STATE OF NORTH CAROLINA
DEPARTMENT OF TRANSPORTATION

Addendum No. 1
RE: Contract # C204039
WBS # 34243.3.2
STATE FUNDED
Polk County (I-4729A)
I-26/US-74/NC-108 Interchange Modifications in the Town Of Columbus

September 19, 2017 Letting

The following revisions have been made to the Roadway plans:

7-AUG-2017 10:15
I:\I-4729A\Roadway\XSC\I-4729A_Rdy_xpl.dgn
$$$$USERNAME$$$$

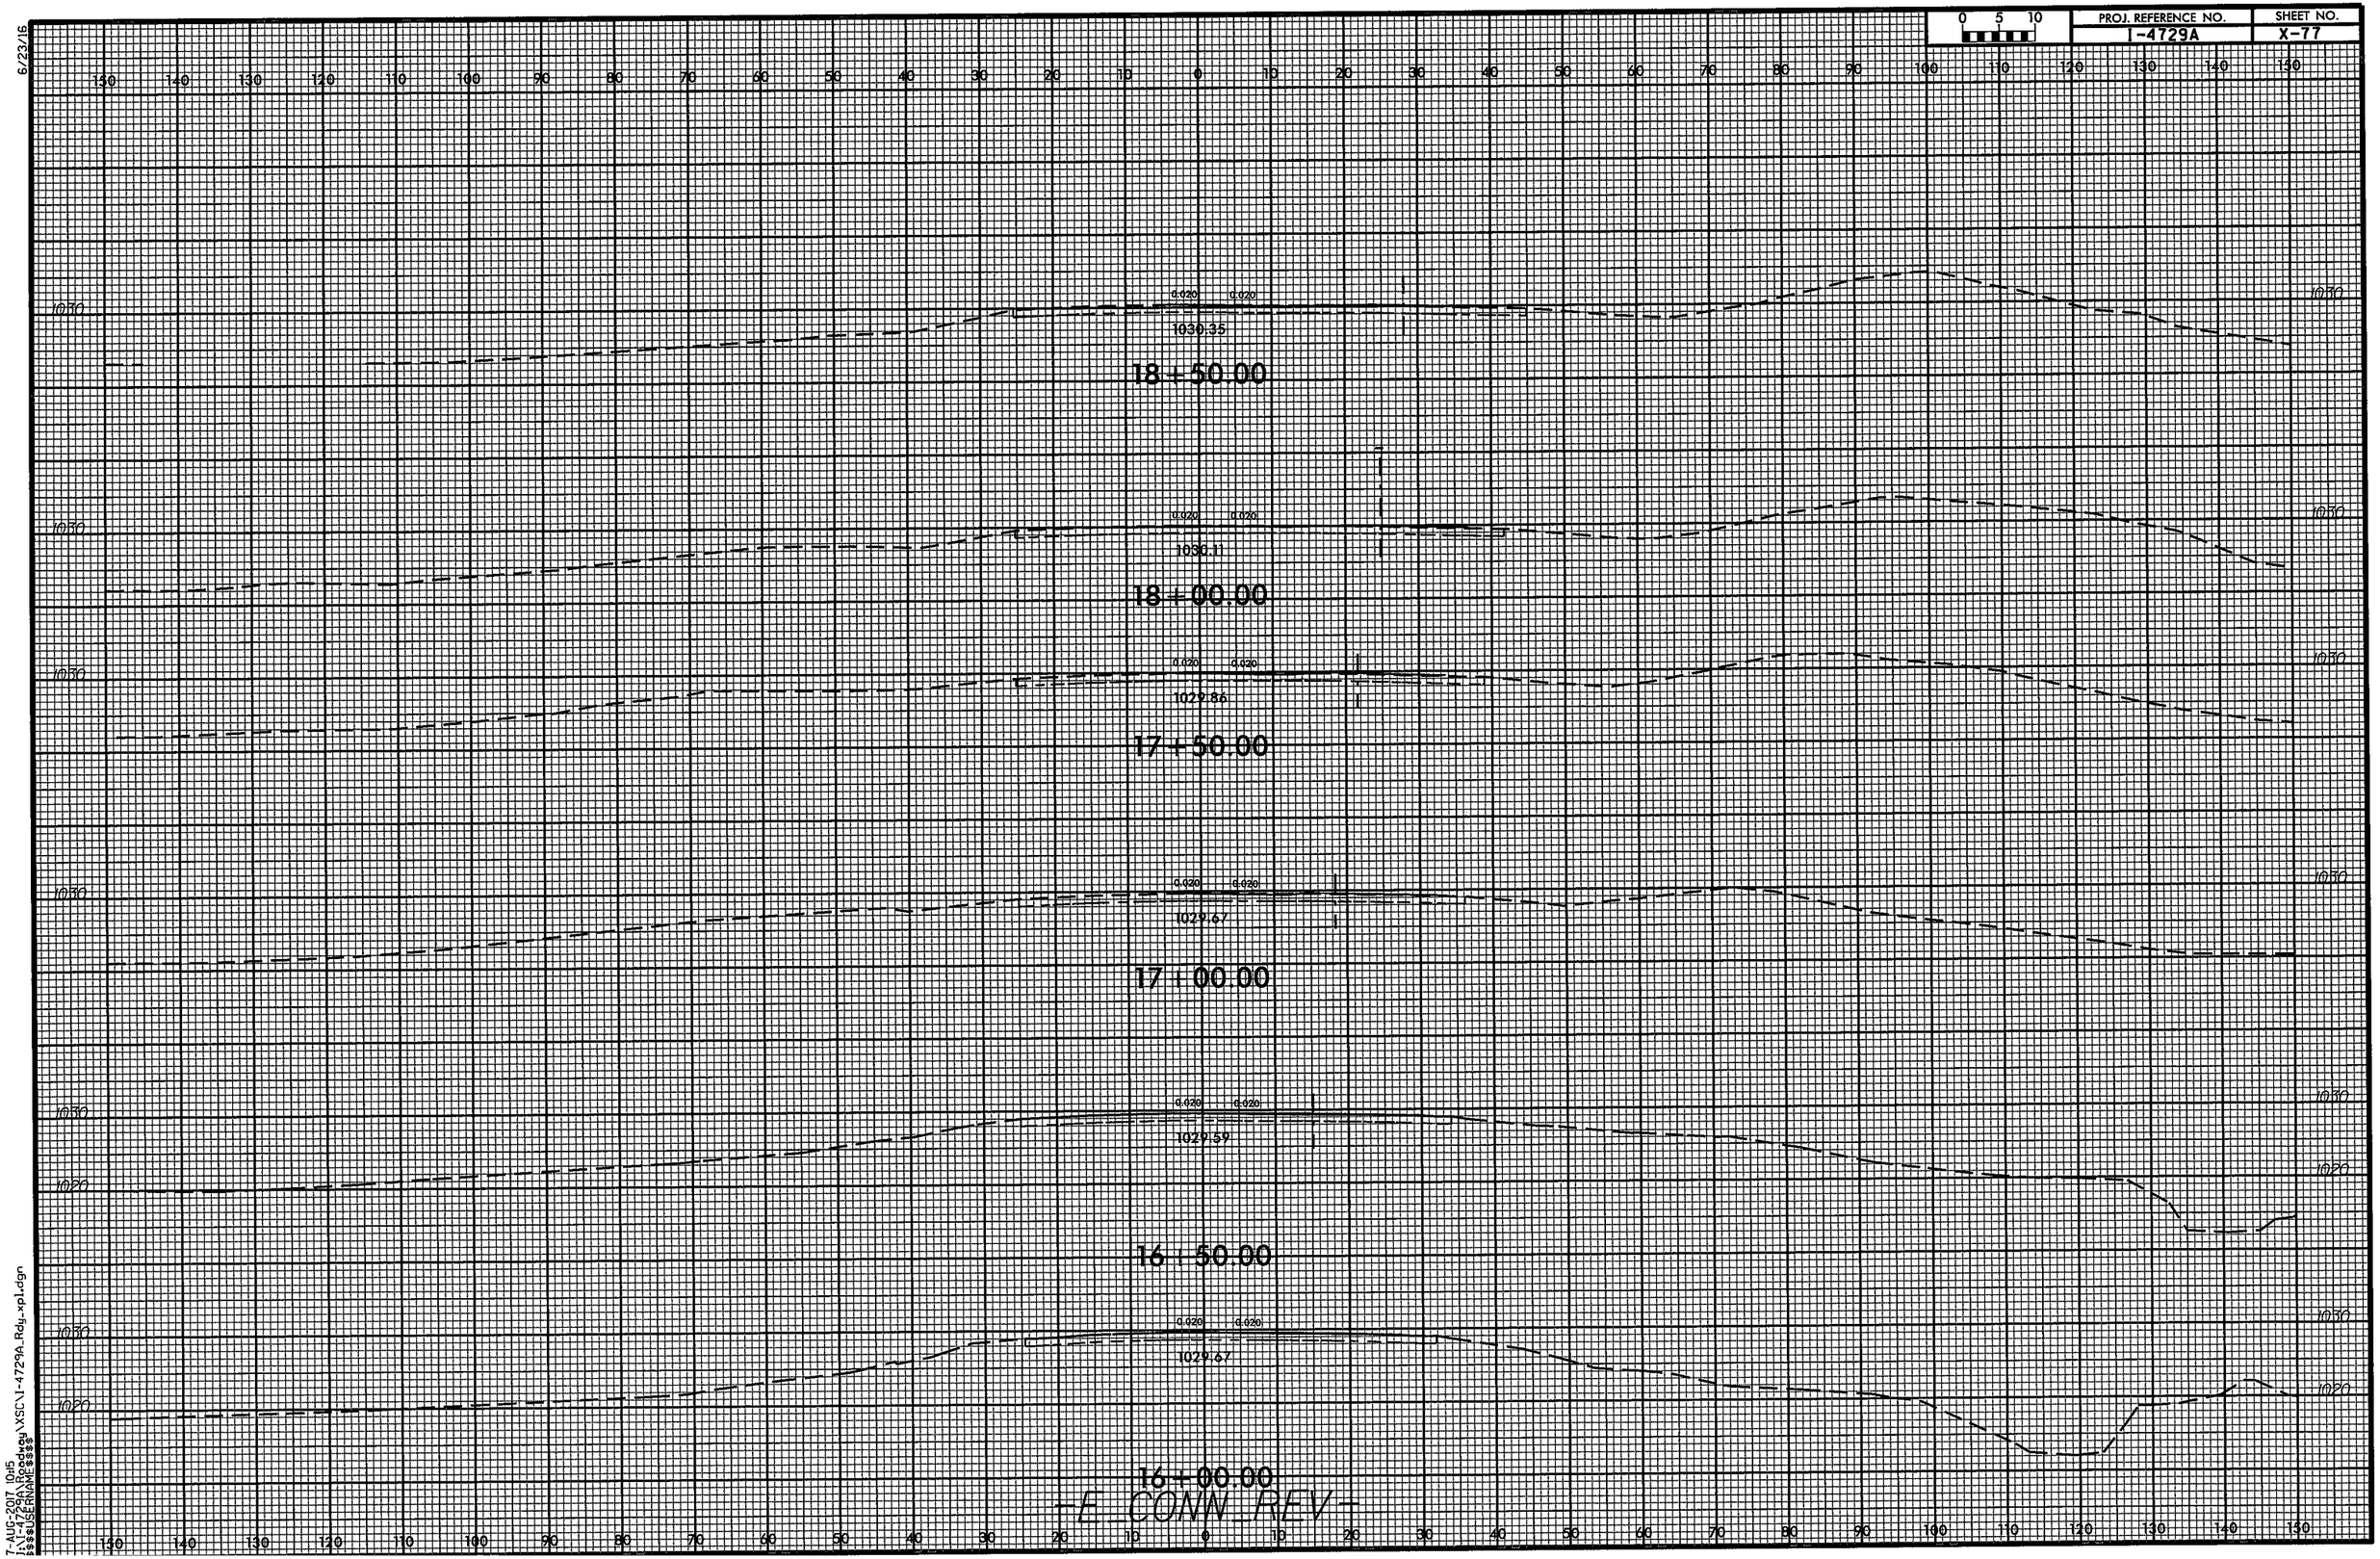
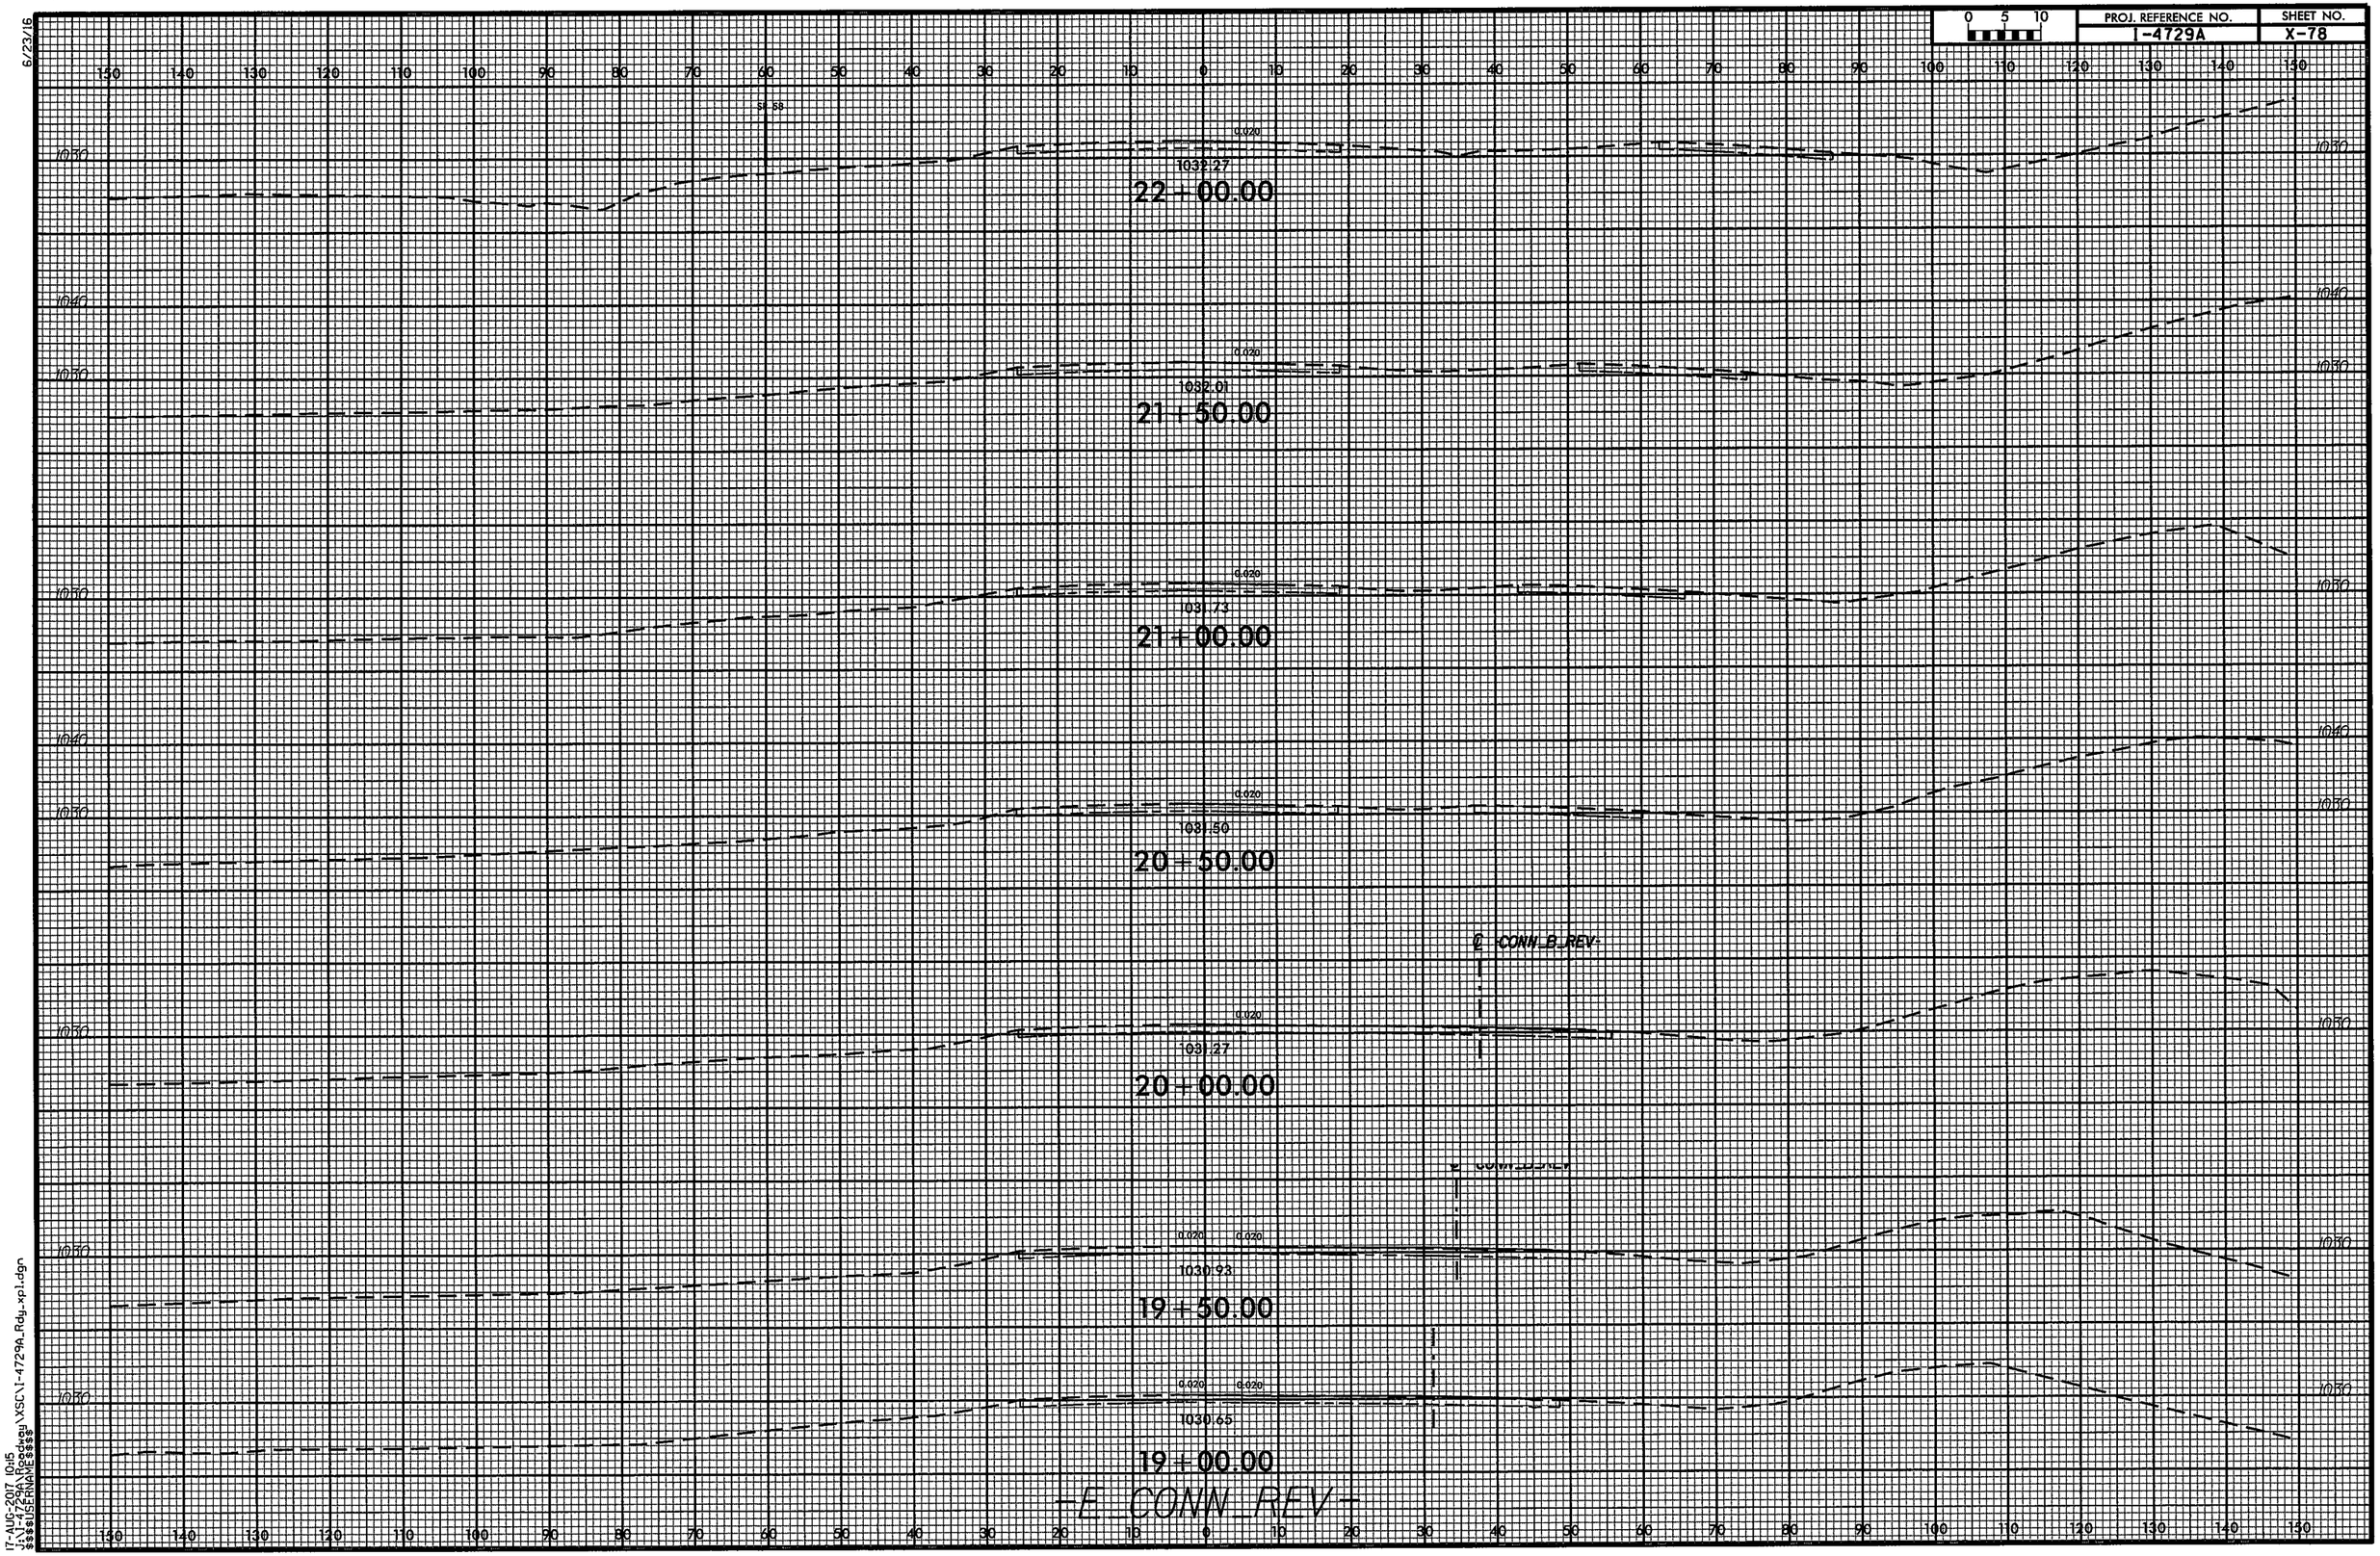
Sheet No.	Revisions
1A	Revised Index of Sheets to remove 2G-2 "Standard Embankment Monitoring Detail" and revise the number of" Drainage Summaries" sheets
2A-1, 2A-4 and 2A-5	Revised the Typical Sections for the change in mainline pavement widening design from ABC to Asphalt Base
3B-1	Revised 'Summary of Earthwork' to account for pavement widening design change
3D-1 thru 3D-4	Various drainage quantity changes as noted below
3G-1	Removed "Settlement Gauge Summary" and added note that Bridge Waiting Period only applies to Approach Slab construction
5	Revised to require Welded Steel Pipe by Trenchless method under the Interstate 26
X-1A thru X-87	Revised Cross-Sections to reflect the change in Earthwork due to the pavement design change
